PMC Servo Rev C

Change Summary and Historical Notes for Rev C

Title: ***Pre-Modecleaner Servo Card***	*Ligo Project* *California Institute of Technology* *Massachusetts Institute of Technology*	LIGO	
Size: D	DCC Number: D980352-C-C	Rev: C	Engineer: *R. Abbott*
File: C:\Ligo\PSL\PSL Schematics\Schematics 9_17\PMC\PSL PMC Servo D980352-C-C.sch			Date: 12/11/2000 Time: 17:48:19 Sheet 1 of 1

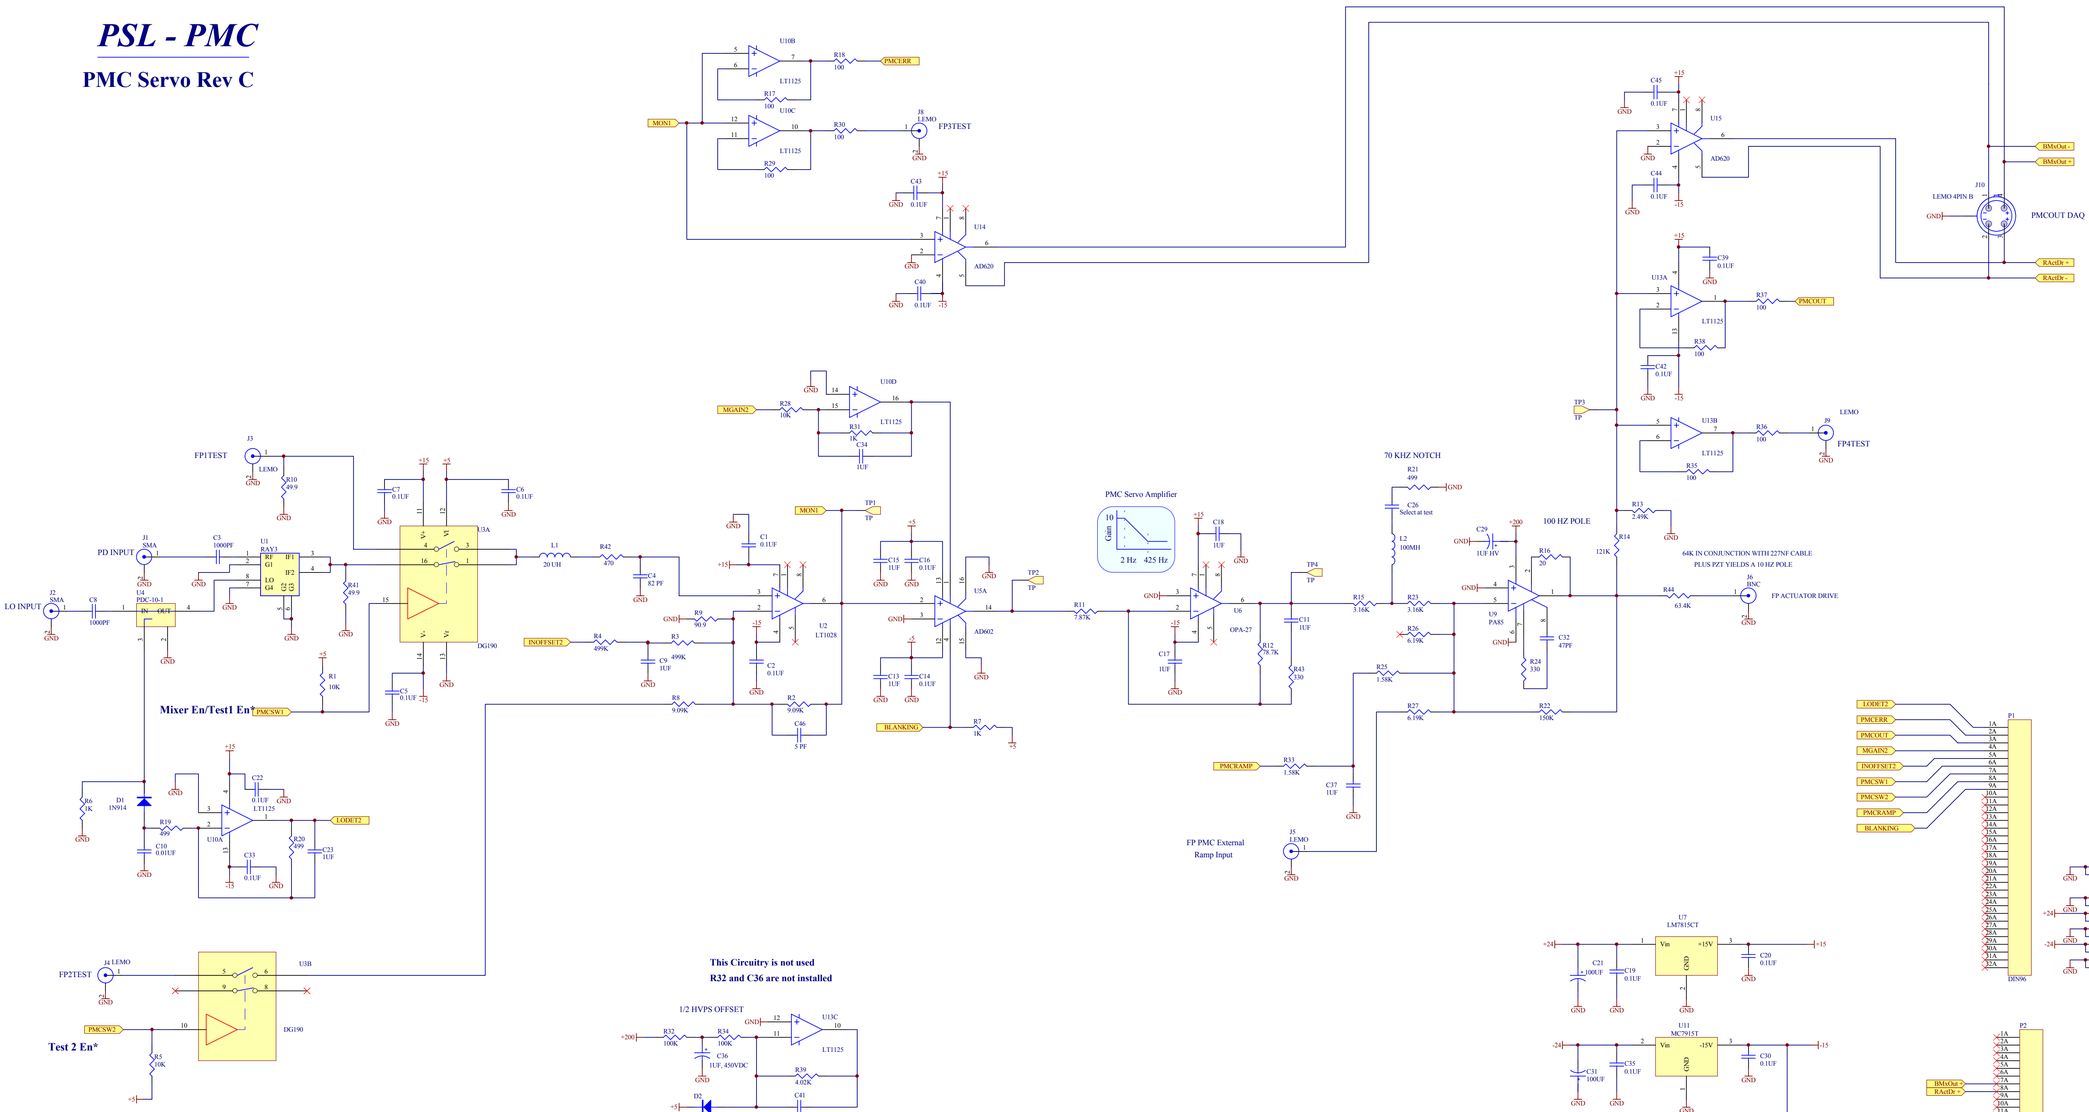
* The External resistor at U9-1 is now R44.

* C24 and C25 are not installed

* R41, R10, R42, L1, C4 form a revised demodulation filter. (Refer to Rev B-C for previous configuration.)

* C46 has been added across R2 in the U2 feedback path.

* R43, R11, R12, C12 form a revised phase lag network. (Refer to Rev B-C for previous configuration.)

*All series BL10xx series boards have these updates.
